Access Compliance Report

Public Rights-of-Way

(Curb Ramps)

Intersection ID: 49931	Main Street: WOBURN_RD	Cross Street: ASHBOURNE_HALL_RD	Location: NW
ADA ID: 86D5E16EE96E	Ramp Type: Perp	Initial Pass/Fail: Fail	Overall Compliance: No
Severity Score: 10			
Codes/Mitigation Info/Possible Solution		Field Measurements/Component Compliance

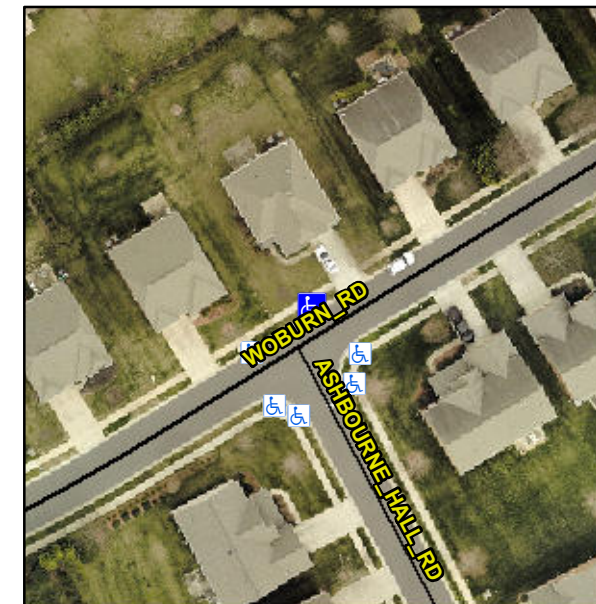
Not Found, R304.5.1

Compliance	Description	Data	Compliance	Description	Data
N/A	Ramp Length (in)	47.0	Yes	Ramp Slope (%)	6.2
No	Ramp Width (in)	47.0	Yes	Ramp XSlope (%)	2.5
N/A	Flare Type LT	N/A	N/A	Flare Type RT	N/A
N/A	Flare Slope LT (%)	N/A	N/A	Flare Slope RT (%)	N/A
N/A	Flare Traversable LT?	N/A	N/A	Flare Traversable RT?	N/A
N/A	Landing Length (in)	N/A	N/A	DWS Provided?	N/A
N/A	Landing Width (in)	N/A	N/A	DWS Contrast?	N/A
N/A	Landing Slope (%)	N/A	N/A	DWS Length (in)	N/A
N/A	Landing X Slope (%)	N/A	N/A	DWS Full Width?	N/A
N/A	Landing Curb? (Y/N)	N/A	N/A	DWS Offset (in)	N/A
N/A	Shared Landing?	N/A			
N/A	Gutter Ponding?	N/A	N/A	Gutter Slope (%)	N/A
N/A	Gutter Lip Ht (in)	N/A	N/A	Gutter X Slope (%)	N/A
N/A	Painted X Walk1?	No	N/A	Painted X Walk2?	N/A
	X Walk 1 Direction	To SE		X Walk 2 Direction	N/A
N/A	X Walk 1 Width (in)	N/A	N/A	X Walk 2 Width (in)	N/A
	X Walk 1 Slope (%)	2.2		X Walk 2 Slope (%)	N/A
	X Walk 1 X Slope (%)	3.9		X Walk 2 X Slope (%)	N/A

Remove & Replace Entire Ramp.
